TECHNICAL SERVICE BULLETIN

Water Leaking On Right Front Floor During Or After A/C Use - Built On 31-Aug-2018 And Through 02-Feb-2020

20-2170

This bulletin supersedes 19-2345 . Reason for update: Add Production Fix Date

Figure 1

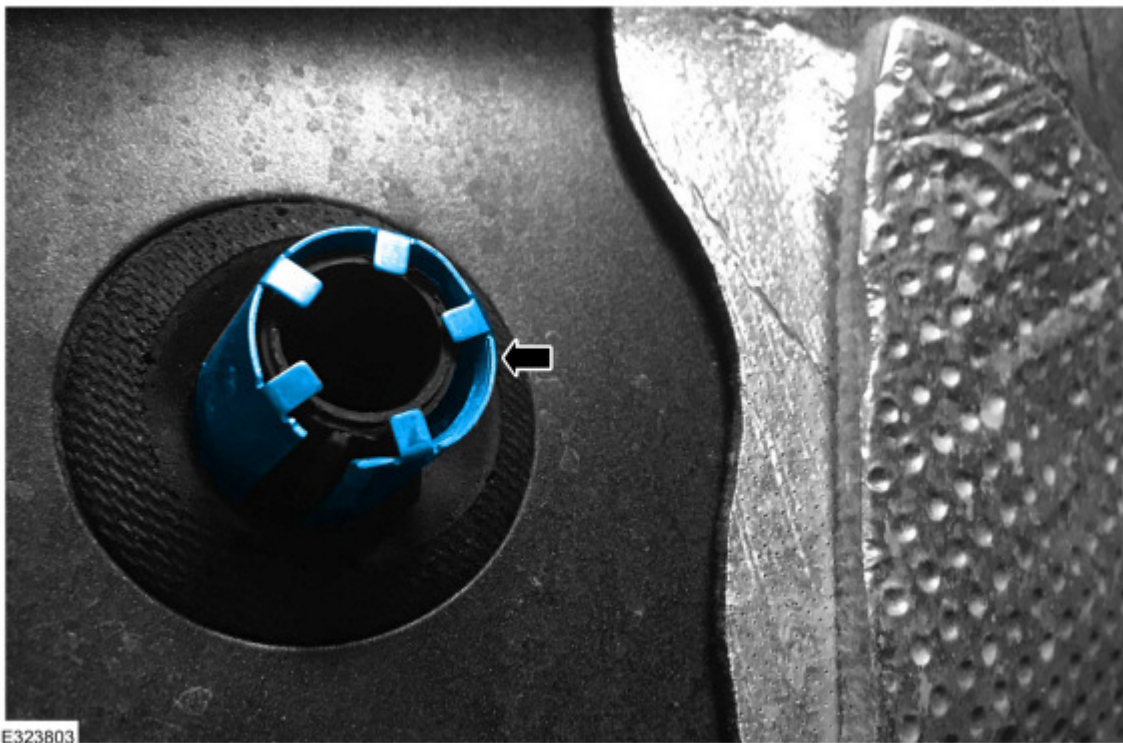
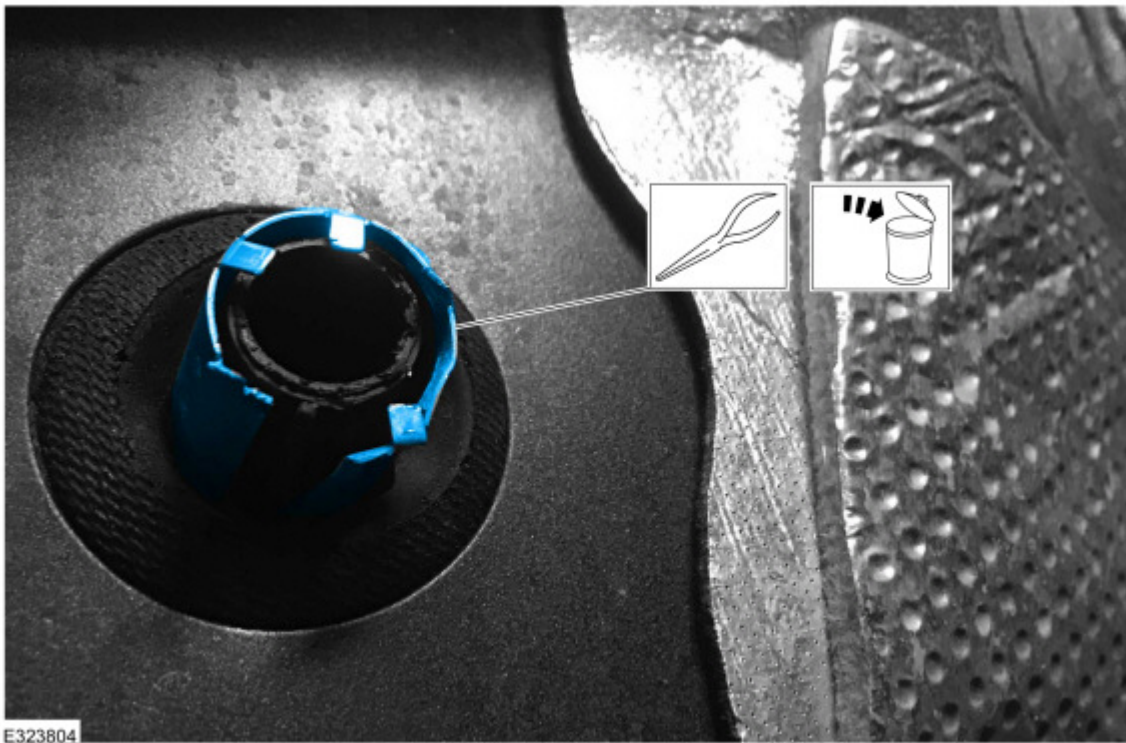
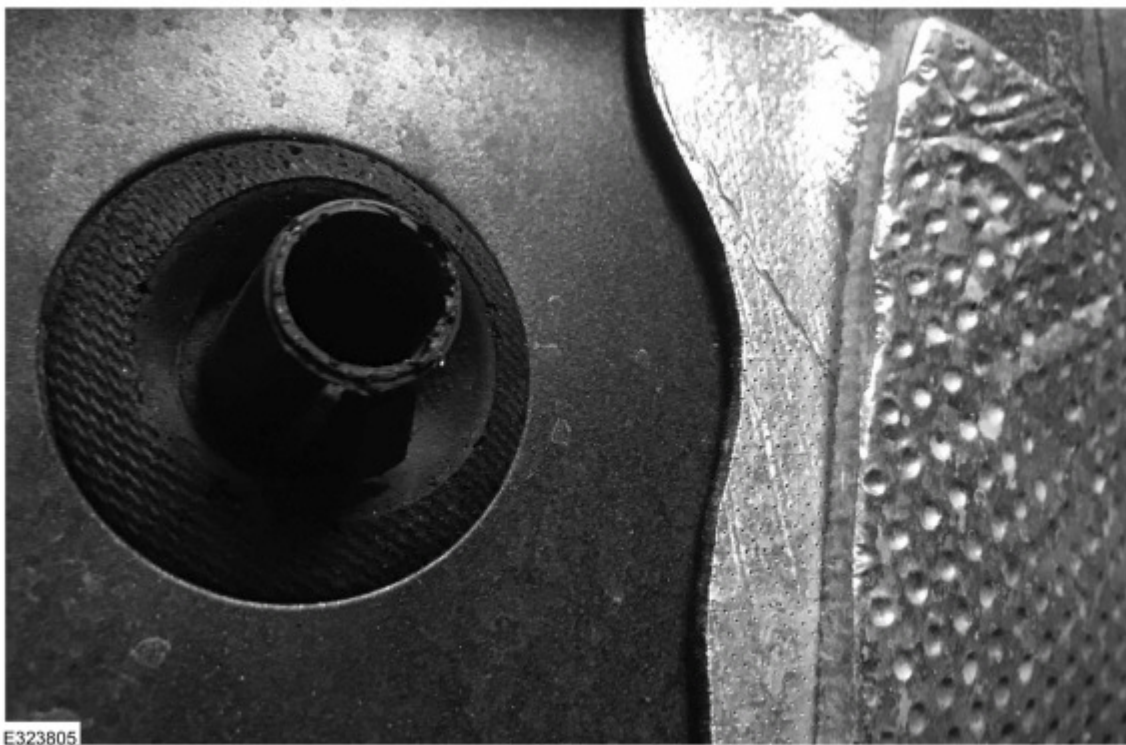
1. Raise the vehicle and remove the right front tire.
2. Remove the right front fender splash shield. Refer to the Workshop Manual (WSM), Section 501-02.
3. Using needle nose pliers or equivalent, remove and discard the metal shield from the evaporator drain tube by bending the tabs away from the tube. (Figures 1-3)

Figure 4

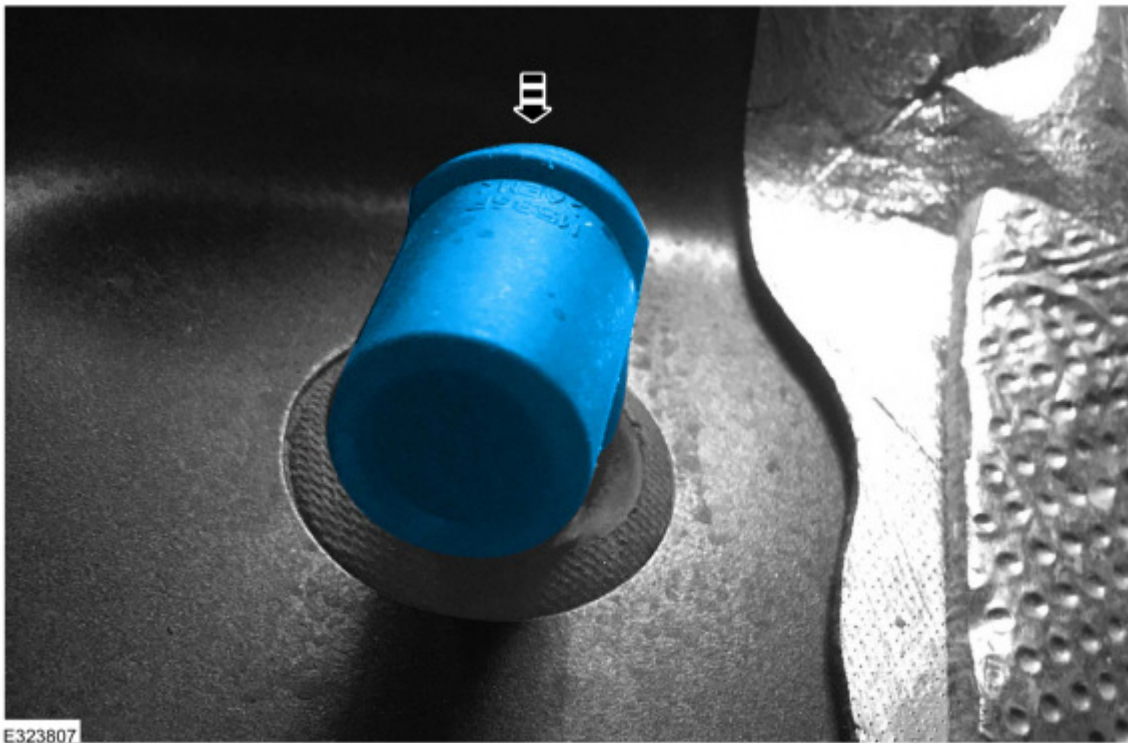
4. Lubricate the inside of the elbow with water. Install the short end of the elbow onto the drain tube. (Figures 4-5)

Figure 6

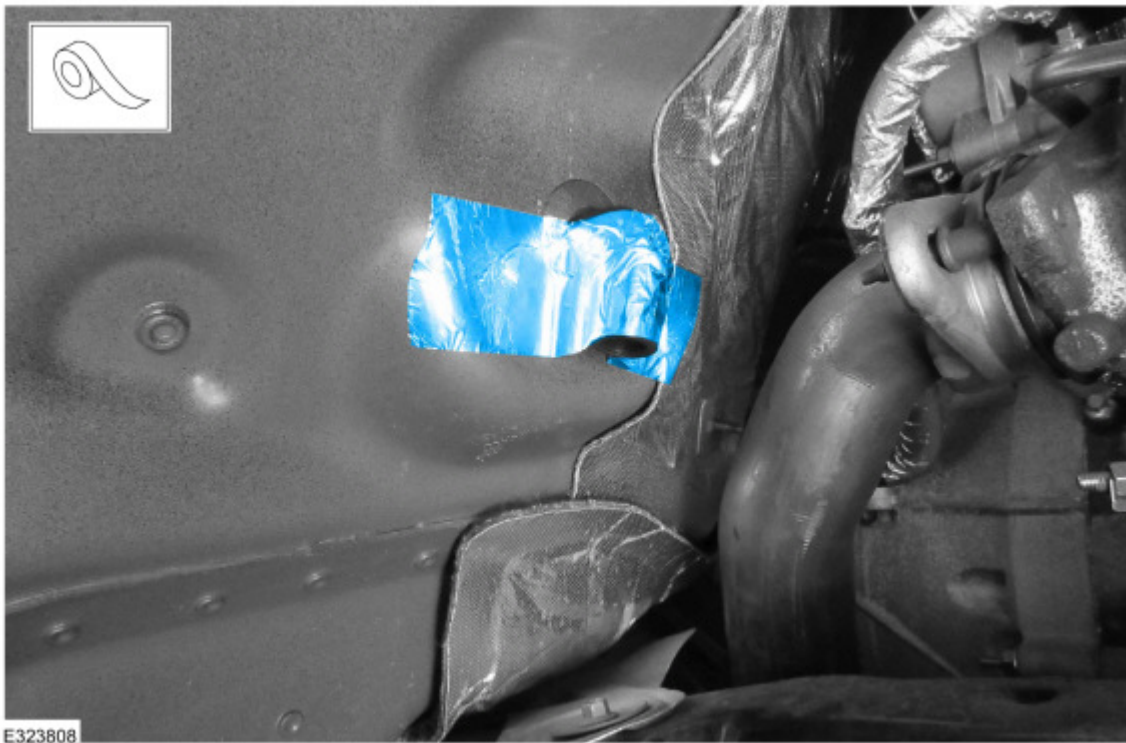
5. Clean the surface of the elbow, drain seal, and surrounding sheet metal with isopropyl alcohol or equivalent.
6. Apply heat shield tape over the elbow as shown in Figure 6.
